3. Document Identifier: 000-00C-MGR0-00500-000-00C	ENG.20080828.0009	4. Rev.: 00C	5. CACN: 002
---	-------------------	-----------------	-----------------

6. Title:  
External Events Hazards Screening Analysis

7. Reason for Change:  
Correct errors in response to Condition Report (CR) 12105.

Figure B5. Physical Parameters Used in Lightning Temperature Rise Calculation

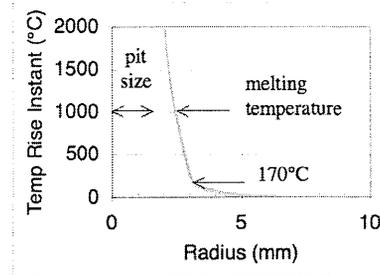
10. Description of Change:  
1. To resolve action 015 for CR 12105, blank cells in the below Tables were modified as described:  
 Table 1 – Cell lines removed  
 Table 2 – Blank cells populated with "N/A"  
 Table 7 – Two rows of blank cells removed  
 Table 8 – Row of blank cells removed  
 Table 9 – Blank cells merged  
 Table A5 – Row of blank cells removed, and blank cells merged  
 Table A6 – Row of blank cells removed, blank cells merged, and dashes ("—") added  
 Table A7 – Row of blank cells removed, blank cells merged, and dashes ("—") added  
 Figure B5 – Image modified to add dashes ("—") to blank cells
